September 21, 2018

Cory-Ann Wind
Natural Resource Specialist
Oregon Department of Environmental Quality
700 NE Multnomah
Portland, OR 97204-1390

Growth Energy represents 100 ethanol producers, 89 businesses associated with ethanol production, and tens of thousands of ethanol supporters across the country. We appreciate this opportunity to comment on the 2018 proposed amendments to the Oregon Clean Fuels Program (CFP). Because of the biofuels industry's tremendous contribution to the reduction of greenhouse gas emissions, we have been actively engaged on low-carbon and clean fuel programs in California, Canada, and around the world. Specifically, we have been engaged with the California Air Resources Board (CARB) on its 2018 amendments to the Low Carbon Fuel Standard (LCFS) regulations including the CA-GREET 3.0 and energy economy ratio amendments that the Department of Environmental Quality is proposing to incorporate into the CFP.

**Comments of Growth Energy on the Proposed Amendments to the
June 20, 2018, Notice of Public Availability of Modified Text and
Availability of Additional Documents and Information for the
Low Carbon Fuel Standard Regulation and to the
Regulation on C

Figure 1. Potential Loss in GHG Reductions and Windfall Revenue Transferred Under CARB’s Proposed Infrastructure “Capacity” Program

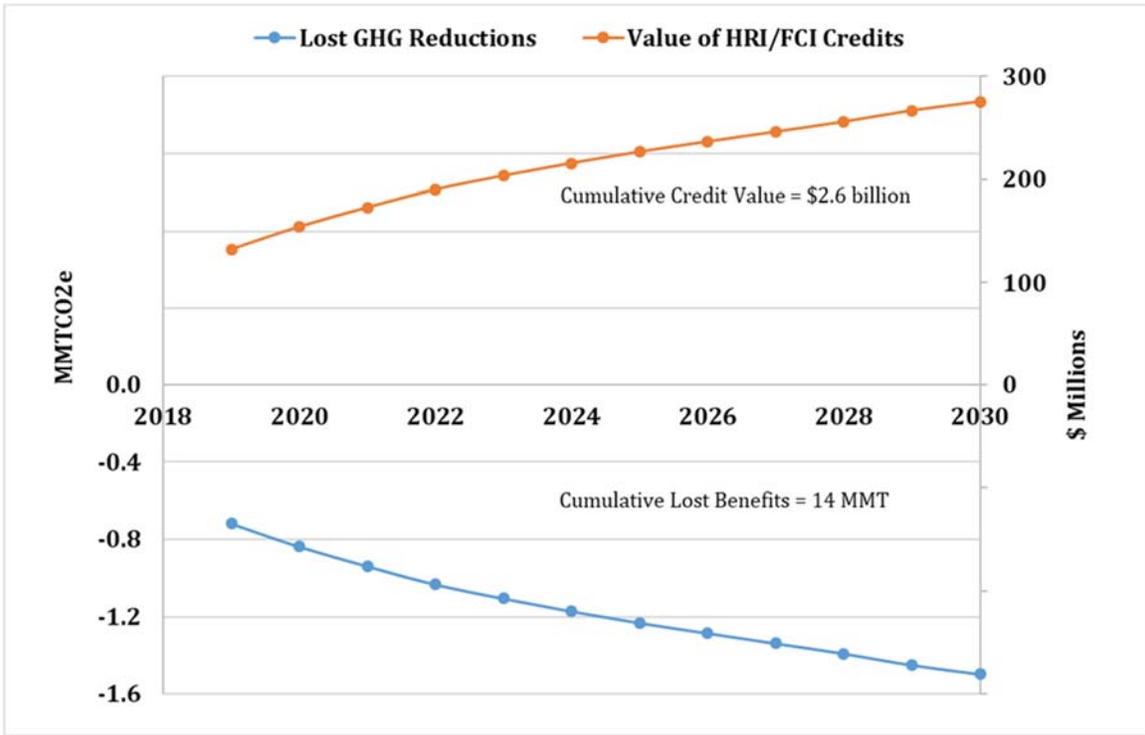
In order to put the potential magnitude of these issues into perspective, Figure 1 shows the estimated maximum amount of GHG reductions that could be lost due to the implementation of Section 95486.2 and the estimated maximum amount of windfall revenue that owners and operators of DC fast charging and hydrogen stations could realize based on the deficit values projected in the August 15, 2018 version of the Illustrative Compliance Scenario Calculator posted on CARB’s website¹ as configured for the “Low Demand” and “Project/LD/Low ZEV/20%/infra” cases. The data in the figure assume that 5% of total deficits each year from 2019 to 2030 are provided as infrastructure credits and that the value of each LCFS credit received is \$184 – the average LCFS credit price for Q2, 2018. As shown, the annual amount of GHG reductions that would not be realized by the LCFS program due to the proposed infrastructure crediting provisions would range from about 0.8 to 1.6 MMTCO₂eq per year and the cumulative loss in GHG emissions from 2019 to 2030 could amount to 14.0 MMTCO₂eq. Similarly, windfall revenue received by operators and owners of DC fast charge and hydrogen stations could amount to about \$150 to \$300 million per year with the potential cumulative value being about \$2.6 billion. Under CARB’s high fuel demand scenarios, lost GHG benefits and windfall revenues would be even greater. It should also be noted that CARB staff acknowledges in Attachment G to the 2nd 15 day notice that accounting for infrastructure credits for hydrogen and DC fast charges is one of the factors that lead to a reduction in the cumulative

GHG benefits claimed for the LCFS program from 117 to 97 MMTCO₂eq (a loss of 17%) compared to the current conditions baseline and from 70 to 63 MMTCO₂eq (a loss of 10%) compared to the business-as-usual scenario.

Figure 2. Comparison of Revenue Associated with CARB Proposed Infrastructure Credits with Available Revenue from Recharging of Light-Duty EVs.

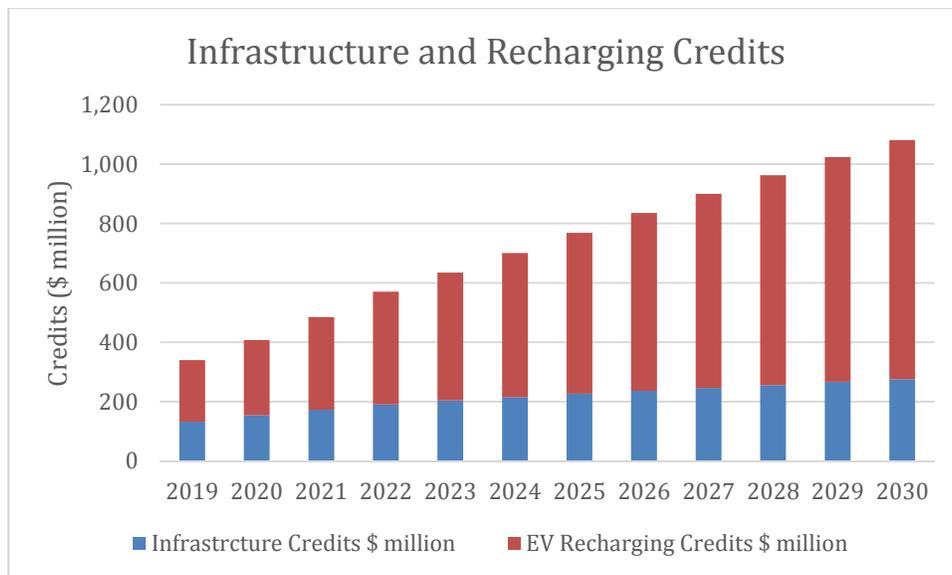
It appears that there should be ample funding available for EV/FCV infrastructure. Figure 2 compares the maximum values of the LCFS credits proposed by CARB staff for

infrastructure, to the total value of credits from recharging of light-duty EVs as documented in the August 15, 2018 version of the Illustrative Compliance Scenario Calculator for the “Low Demand” and “Project/LD/Low ZEV/20%/infra” cases. As shown in Figure 2, the magnitude of the value of the infrastructure credits proposed by CARB is small compared to the value of the credits that EDUs receive from residential EV recharging. Although availability of DC fast charging to the extent that such capacity is actually needed could “benefit the current or future EV drivers across California,” CARB would simply have to change EV to “Zero Emission Vehicle (ZEV)” to allow for the use of funds from EV recharging to also support hydrogen station infrastructure, which could obviously benefit current or future FCV drivers across California.

Based on the above, CARB should abandon its proposal to create LCFS credits that are not based on actual GHG emission reductions to support DC fast charging and hydrogen stations. Instead, CARB should simply require that the surplus credit value generated by the EDUs beyond those needed for the point of purchase rebate program be used to provide funding for underutilized DC fast charging and hydrogen stations. In addition, CARB should use these surplus funds to promote the development of infrastructure for other low-CI fuels such as E85, as use of E85 in California is dramatically limited by the lack of a widespread distribution and dispensing infrastructure.
